SERVICE No. 132 BULLETIN

Piper Aircraft Corporation

SUBJECT: Fuel Valve Actuator Handle Locks

MODELS AFFECTED: PA-23, serial 23-1 to 23-100 inclusive

FUEL VALVE CONTROL LOCK
KIT-754068

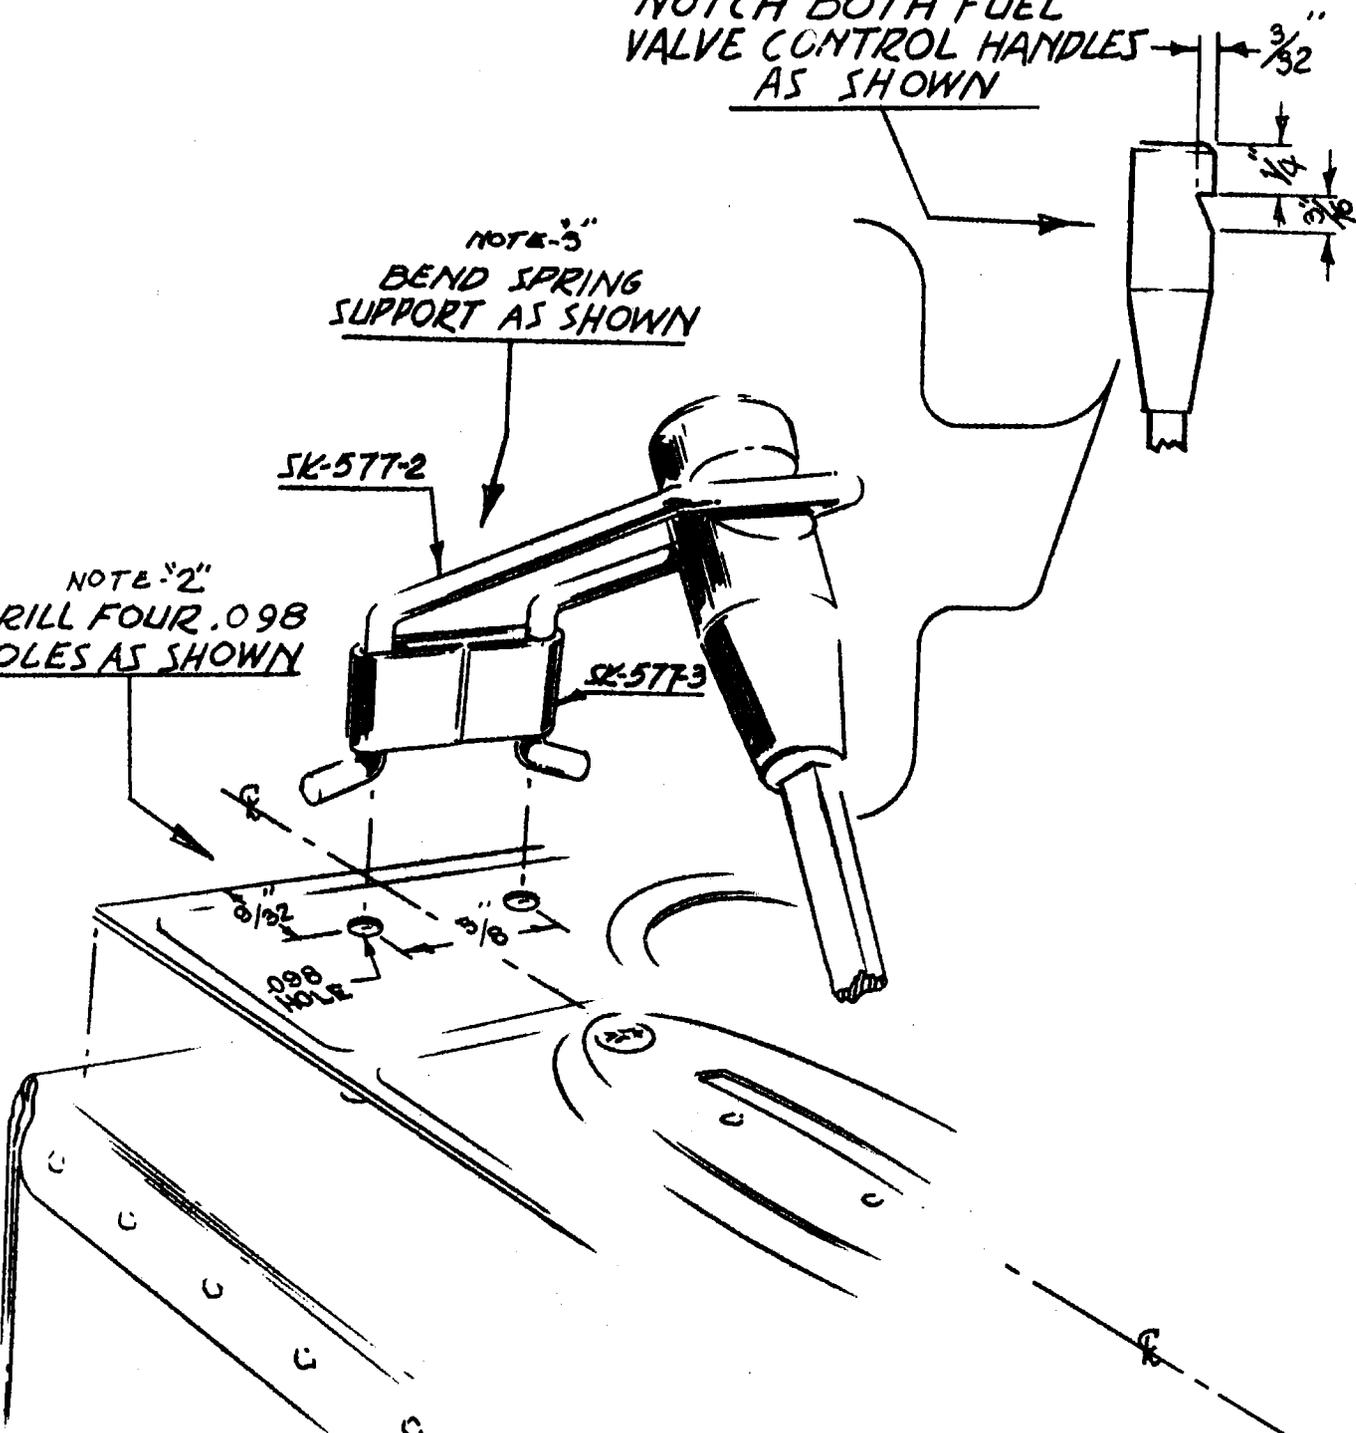
It is requested that the above listed aircraft, not equipped with fuel valve locks, be modified to incorporate Fuel Valve Lock Kit, 754 068.

NOTE-1"
NOTCH BOTH FUEL
VALVE CONTROL HANDLES
AS SHOWN

NOTE-3"
BEND SPRING
SUPPORT AS SHOWN

NOTE-2"
DRILL FOUR .098
HOLES AS SHOWN
